SIEMENS

July 30, 1996

License No. SNM-1227

Docket No. 70-1257

FIGURE II-10.27a

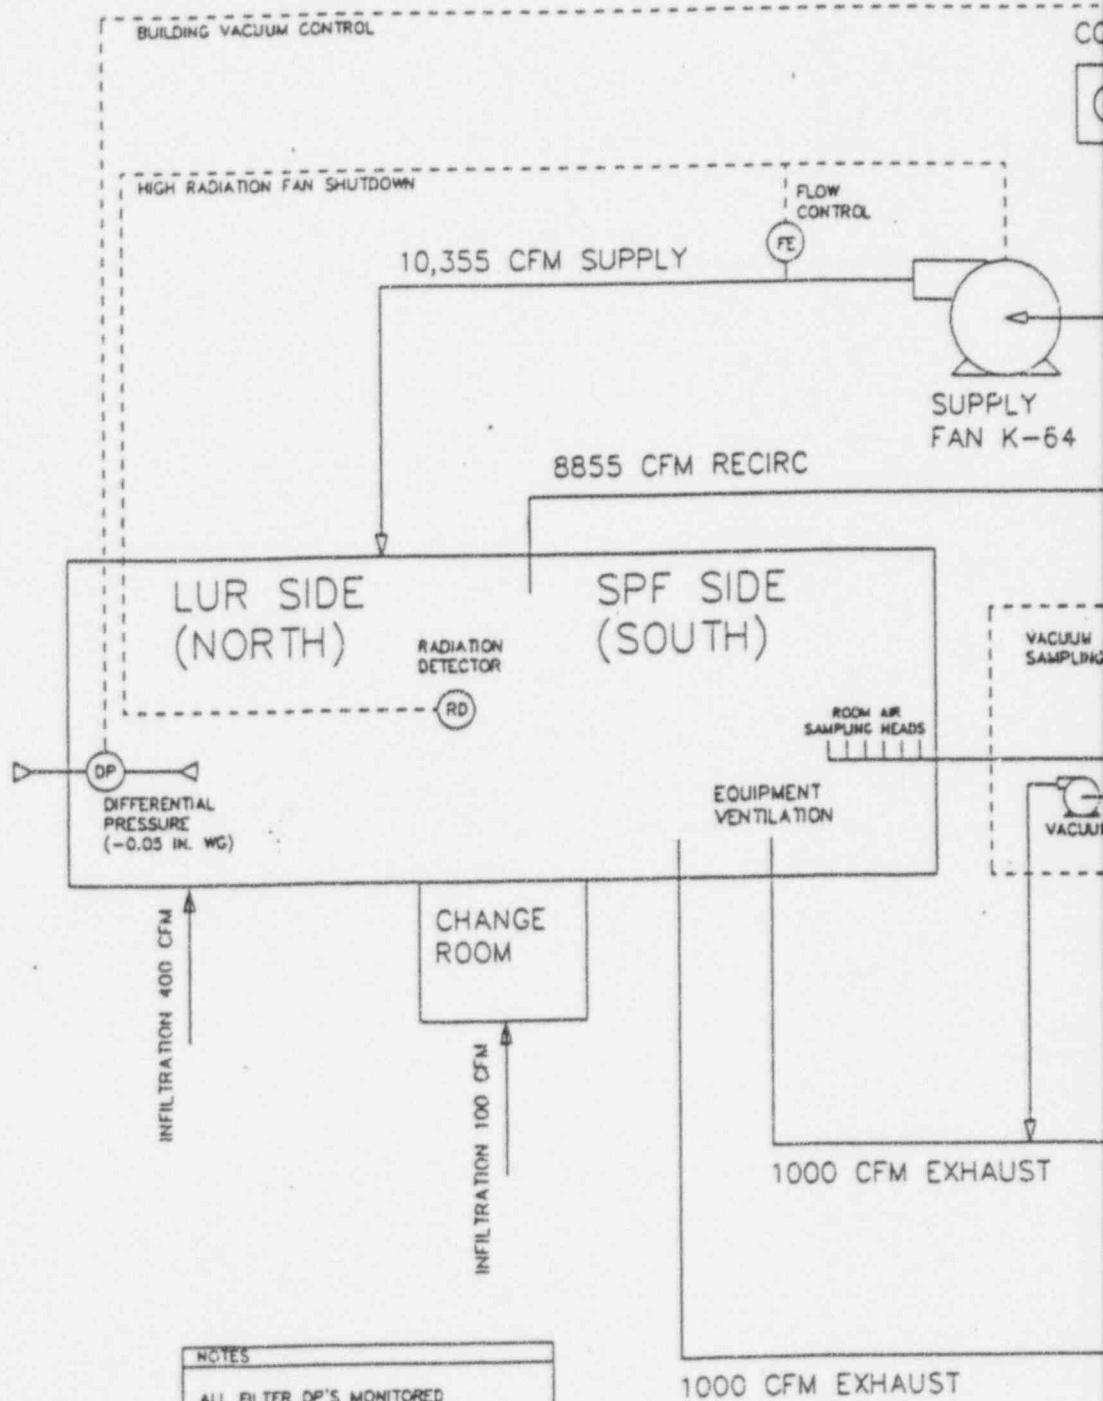
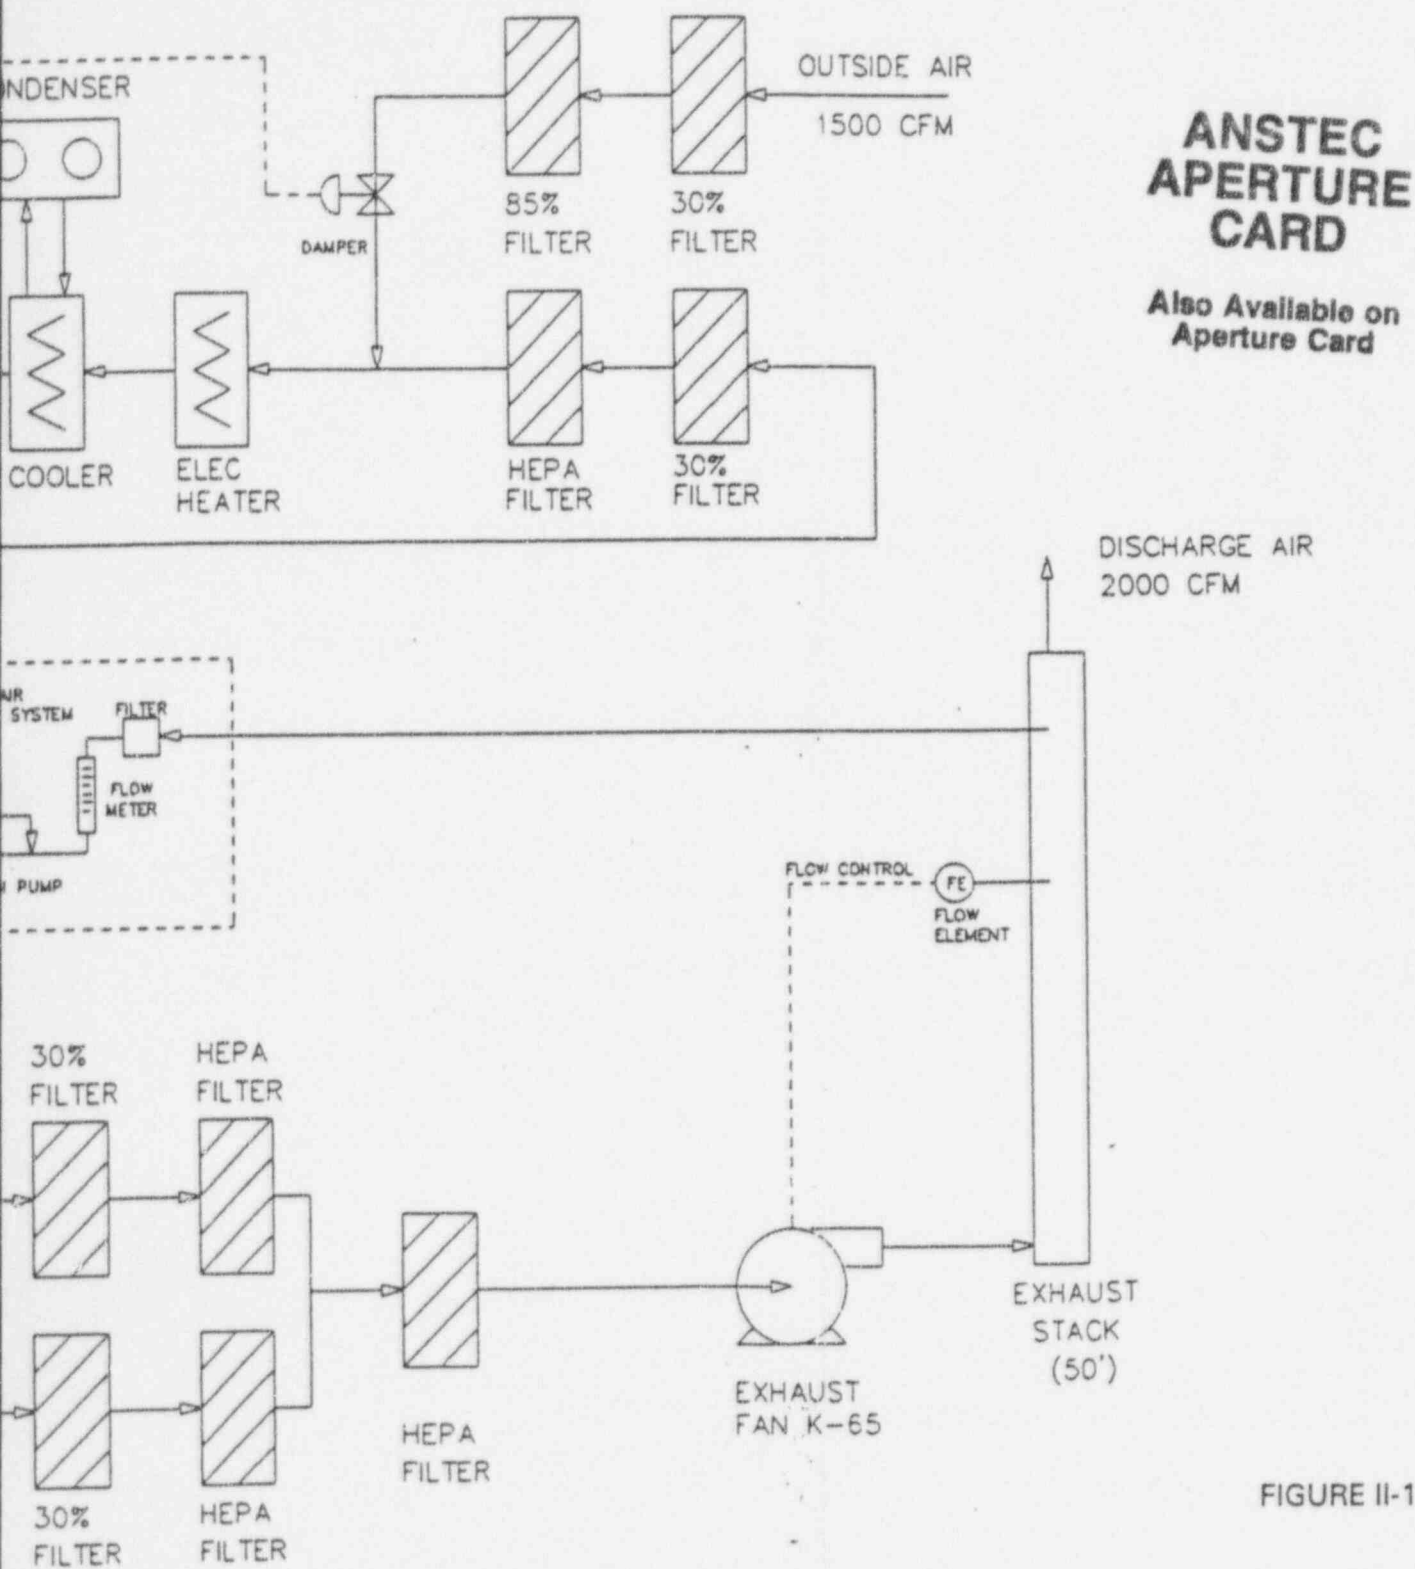
As described in the referenced letter, the HVAC system is sized to accommodate both the LUR building and the SPF addition. The significant change to the HVAC system from that described previously is the provision for recirculating facility air.

The building air supply and heating system will consist of a pad, ductwork, prefilters, an air-conditioner, electric heater, instrumentation and an air supply fan. The supply fan will supply 1,500 cfm of outside air and recirculate approximately 8,800 cfm of building air. The recirculated air passes through a roughing filter and a HEPA filter and is continuously monitored for airborne radioactivity. The building air filtration and exhaust system will consist of a pad, ductwork, a HEPA air filtration unit, a 2,000 cfm exhaust fan, a 50 foot exhaust stack, an isokinetic stack gas sampler, instrumentation and room air monitoring equipment. A flowsheet for the building HVAC system is shown on Figures II-10.27a in the existing license or II-10.27b in the renewal application.

The general features of the LUR/SPF HVAC system include a combination of a once-through airflow and recirculation supply system (K64) and a double HEPA filtered exhaust system (K65). A simplified schematic diagram of the HVAC system is shown in Figure II-10.27a.

The K64 air supply and recirculation system supplies approximately 1500 ft³/min. of outside air and also recirculates approximately 8800 ft³/min of building air. Recirculated air is passed through a roughing filter and a single HEPA filter with an installed efficiency of 99.95% for 0.8 micron DOS cold-generated aerosol. Provision is made in the K64 recirculation system for continuous alpha radiation monitoring of recirculated air upstream of the HEPA filter bank. The alpha air monitor is set to alarm and annunciate when alpha activity exceeds 8 MPC-hr.

FIGURE II-10.30

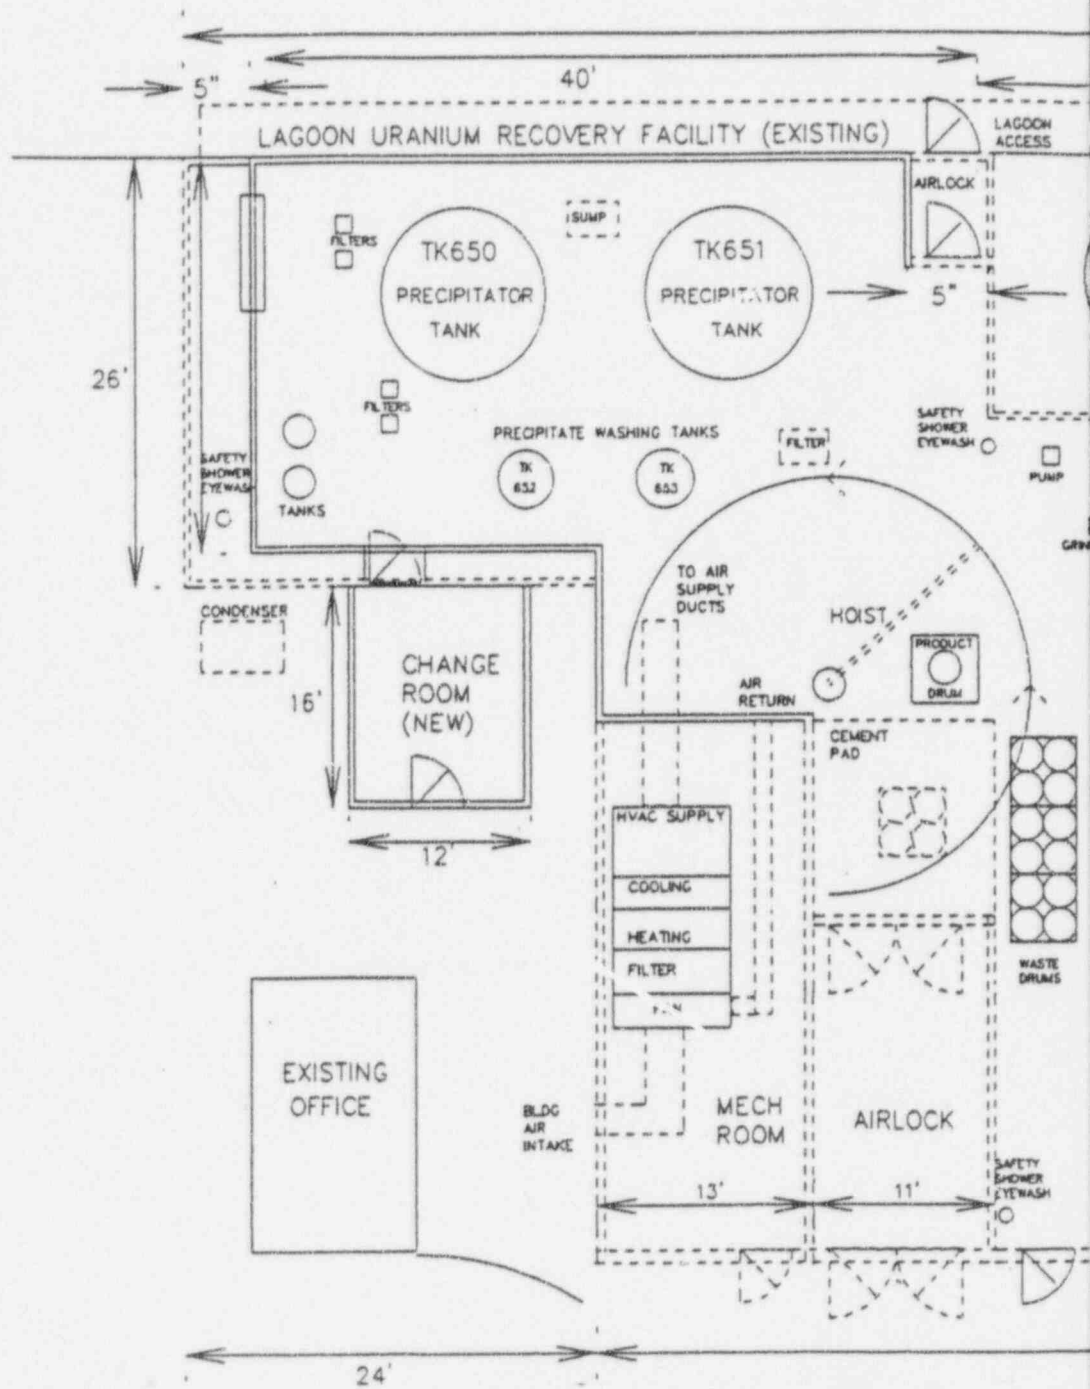
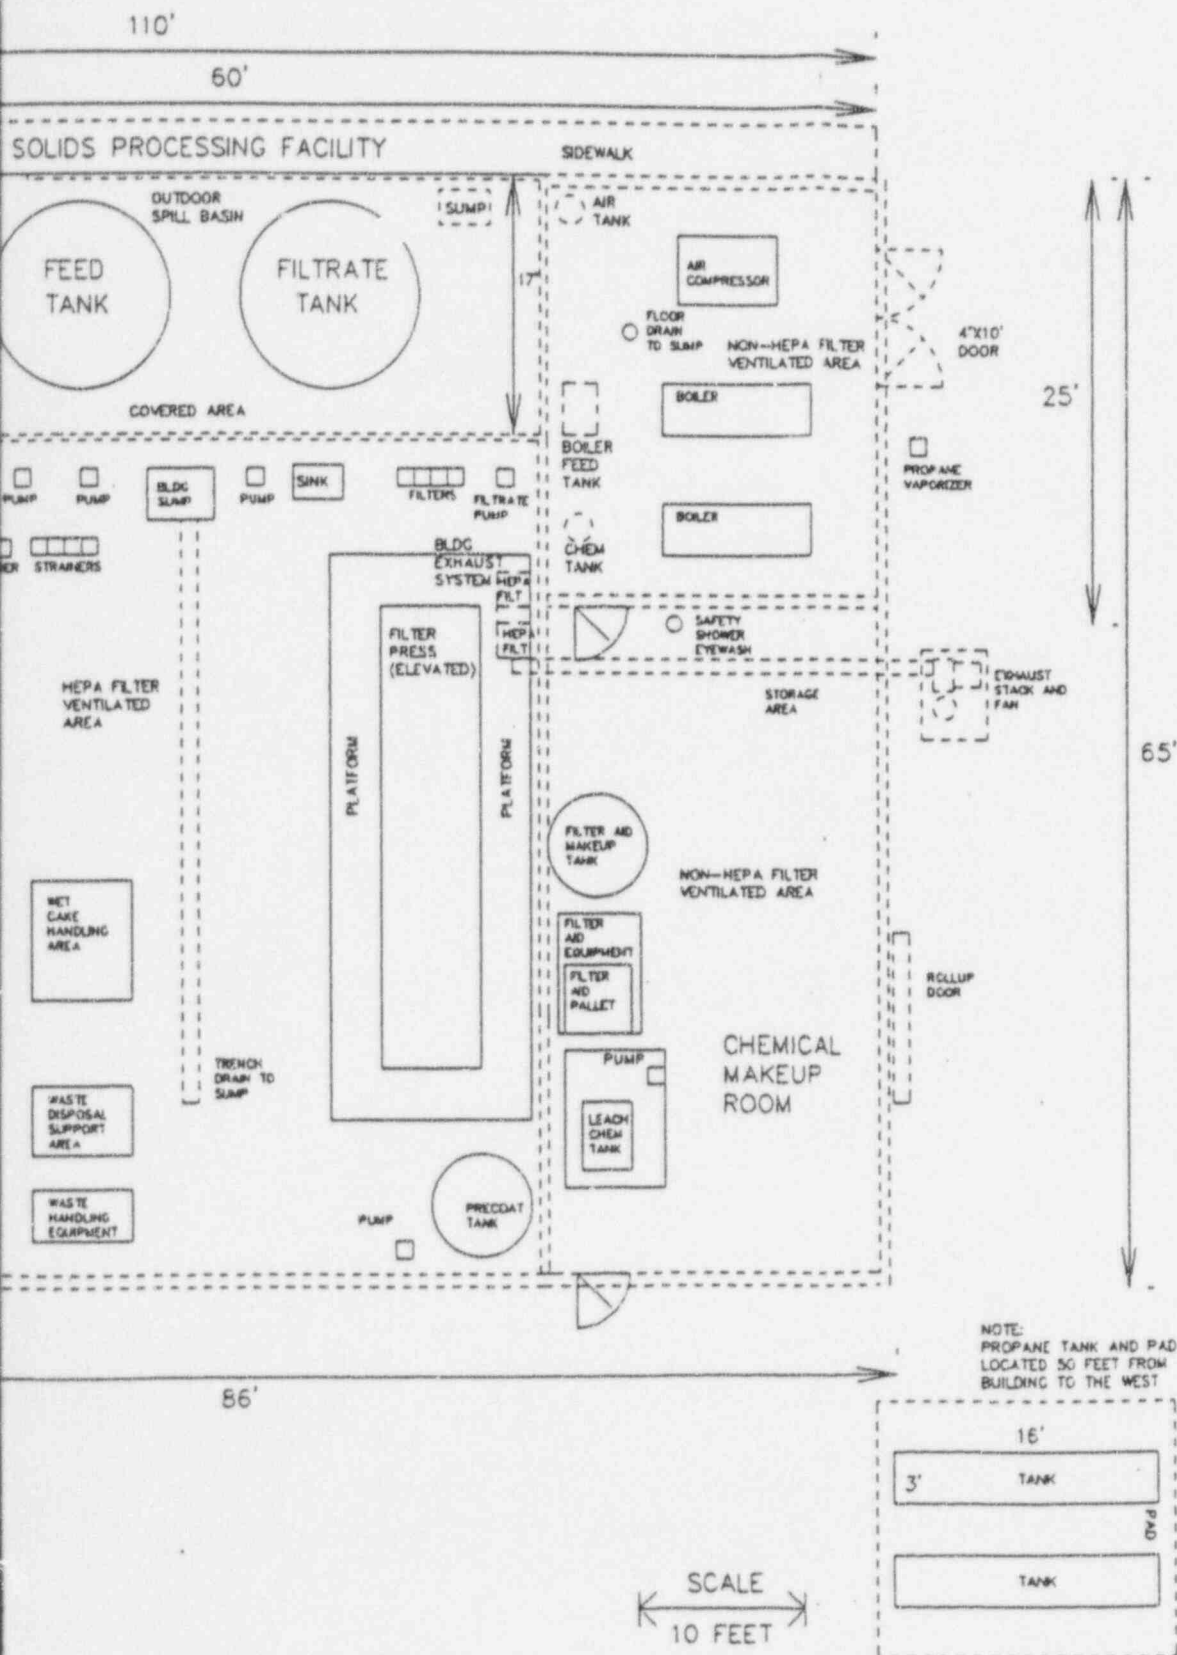
The LUR enclosure described in the referenced letter has been changed slightly. What was the existing office is now a break room. The previously described change room and airlock have been slightly reduced in size and the mechanical room, containing the supply fan, heating equipment and filter, has been relocated between the change room and airlock.

The SPF consists of a 60 x 65 foot addition to the south side of the LUR building to be built concurrently with the LUR building. One building will therefore enclose both the existing LUR process and the SPF equipment. The overall building size will be approximately 110 feet x 65 feet. A foundation will be laid around LUR and to the south of LUR, and structural steel will be erected. Insulated wall panels and roofing will be mechanically attached, as described in the referenced letter. A single sloped roof will enclose all LUR and most SPF equipment, 32 ft. high on the east to 18 ft high on the west. An airlock for forktruck access will be provided on the west side as will access to the chemical and mechanical equipment rooms. Access doors will be provided for the steam generator room on the south side. A lagoon access personnel airlock will also be provided on the east side. See Figures II-10.30 in the existing license and renewal application for a building/equipment layout diagram.

The SPF is provided to recover LEU entrained in the solids in the bottoms of the lagoons and put the uranium into solution to be fed to LUR. The SPF process equipment is located in the south end of the building that encloses LUR. LUR and SPF share the same HVAC system. The SPF process equipment consists of two feed and product tanks, two additive makeup tanks, a filter press, and associated filters, pumps, piping and a steam generator. A brief description of the major SPF equipment is included in Table II-10.2 and the equipment layout is included in Figure II-10.30.
